SUBJECT: REQUEST FOR PROPOSALS FOR THE PERFORMANCE OF EXPERT PROFESSIONAL SERVICES FOR THE ADVANCEMENT OF CONCEPTUAL DESIGN WITH OPTION FOR “AS-NEEDED” TECHNICAL ADVISORY SERVICES FOR THE LINCOLN TUNNEL HELIX REPLACEMENT PROJECT– RFP NO. 58219- ADDENDUM # 2

The Port Authority of New York and New Jersey (the Authority) hereby amends the subject Request for Proposal (RFP), dated August 21, 2019, as follows:

Figure 1 – Traffic Simulation Study Area

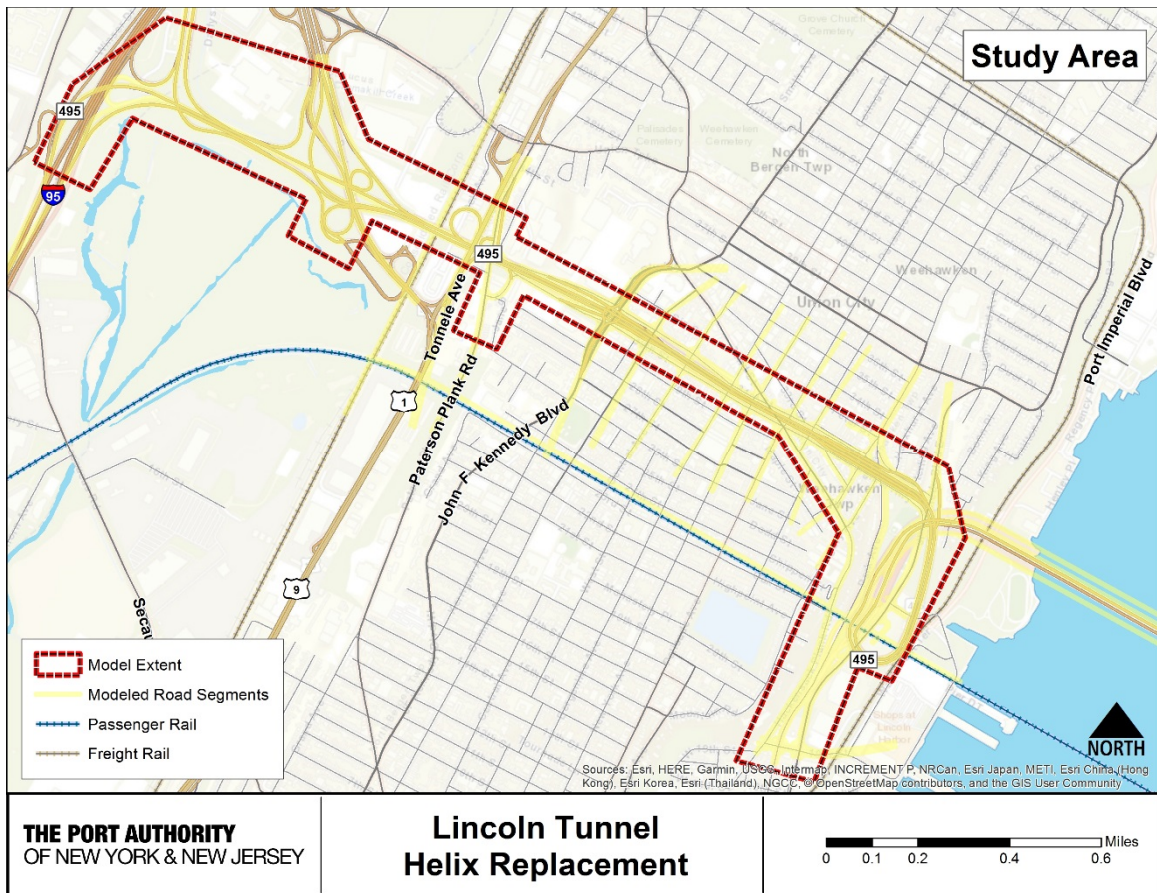
- 1) In the RFP Attachment A Scope of Work, page 21, Task D. Field Services subsection 2a **Insert:** Appendix A Traffic Model Study Area -Figure 1 Traffic Simulation Study Area and Figure 2 Traffic Simulation Model Map.

Question 3: Can the Authority please provide copy of the AIMSUN model to proposing entities, such that a better understanding the modeling completed to date can be understood in order to requested understand the scope of modeling work. If the model cannot be made available can a map of the roadway network included in the AIMSUN model to estimate the required modeling effort and cost?

Answer 3: The full AIMSUN model will not be made available until after the award of Proposal. See Appendix A Traffic Model Study Area.
